Investigation No. 2120.

Metallurgical Examination of a Second Defective
Cast Iron Cylinder Head Casting.

R E P O R T
of the
ORE DRESSING AND METALLURGICAL LABORATORIES.
Investigation No. 2120.

Metallurgical Examination of a Second Defective
Cast Iron Cylinder Head Casting.

Figure 4.

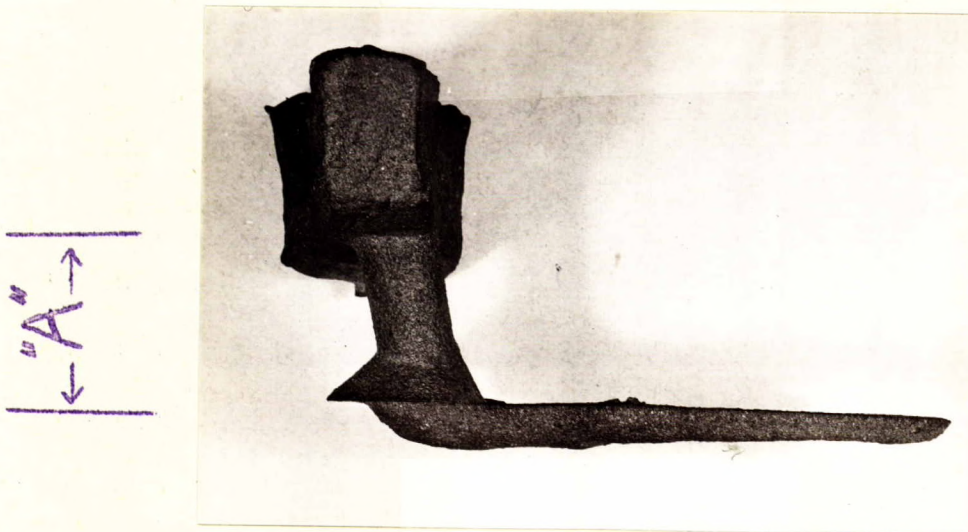
Pouring height "A" appears to be too low.

The low pouring head as used at present may be increased to give additional ferrostatic pressure. (The above dimension "A" is only two inches on the actual casting.)

1. Increase the pouring head or height of the pouring basin above the casting, as suggested in Figures 8 and 9.

The above pouring method shows a cross-sectional view through the two large round cores. The increase in pouring height over that used as shown in Figure 4 can be easily increased to 8 or 10 inches if additional ferrostatic head is considered necessary to overcome shrinkage porosity.

Figure 7.

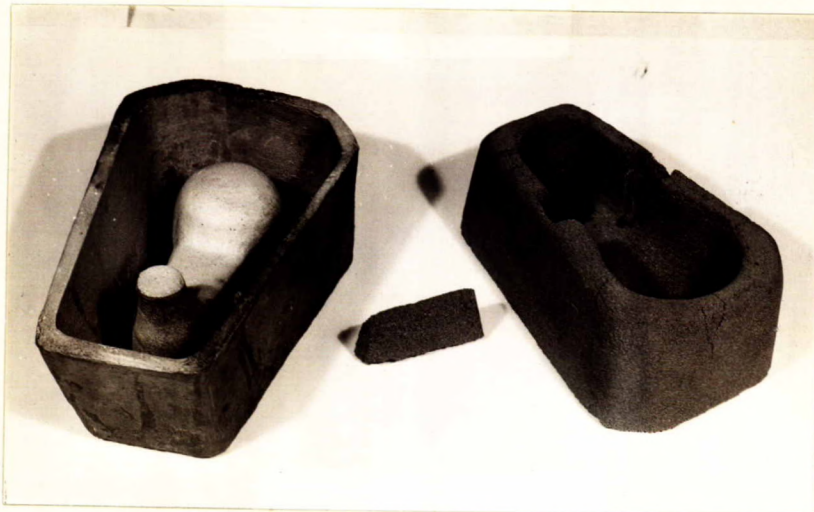
Figure 7 shows a baked sand core which can be used for controlled pouring and slag check gate in the runner-box. The left-hand view shows the core box used for making the pouring basin.

2. Adopt, as standard practice, the use of a baked sand pouring-basin rammed up on top of the mould to provide a clean, baked receptacle for the molten metal.

Figure 8.

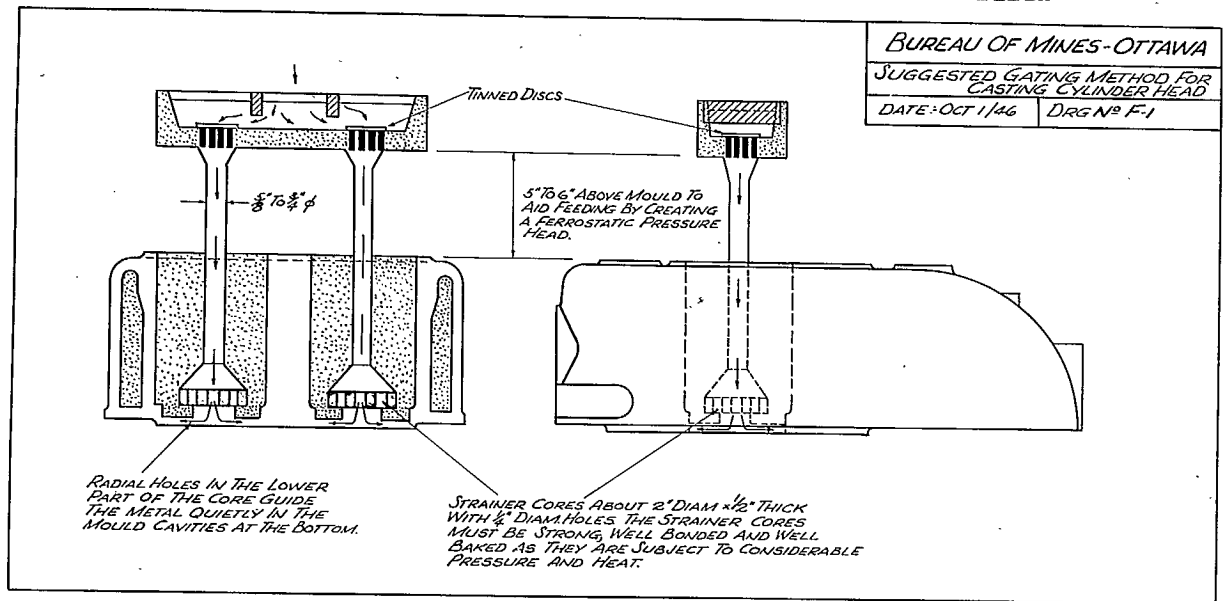
Figure 8 shows one method of controlled pouring directly down the two centre cores,

Figure 8 also shows side elevation of pouring through centre cores.

The suggested sizes of sprues, and number of strainer-core holes may be altered to increase or decrease the metal flow at particular locations.

Figure 9.

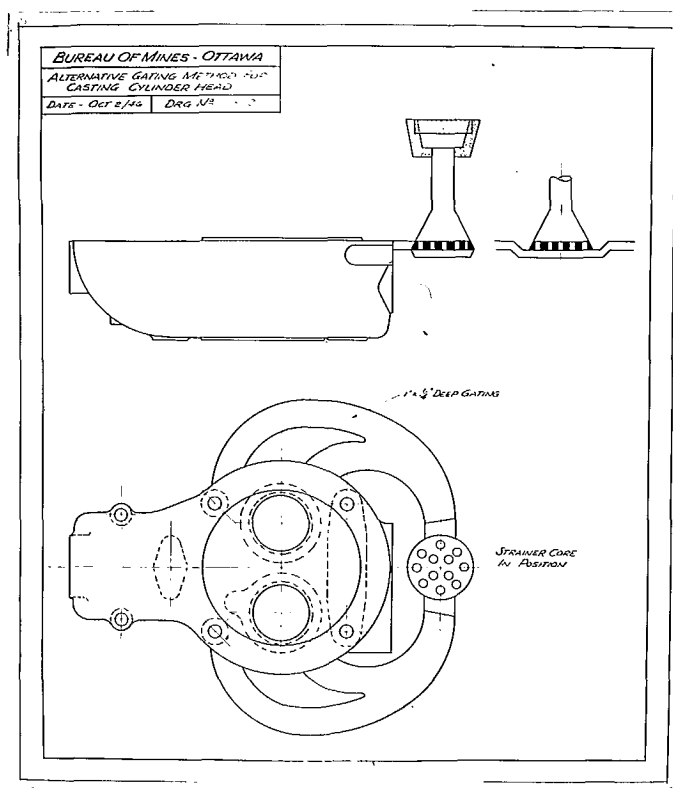
Figure 9 gating shows a uniform distribution of metal into the casting from the top. In this manner, no one gate is subjected to excessive heat and erosion from the metal. This type of gating would best be made into a loose wood pattern and thus make clean, standardized gates, from mould to mould.

In this gating method the same principle of ferro-static pressure can be applied to overcome shrinkage porosity, by increasing the pouring-basin height 6 or 8 inches above the casting.

The entrance of the metal on both sides of the casting tends to produce a more uniform distribution of metal flow into the casting.

From the cost point of view the method of casting in Figure 9 may involve less drilling and work in gate removal than the method shown in Figure 8.
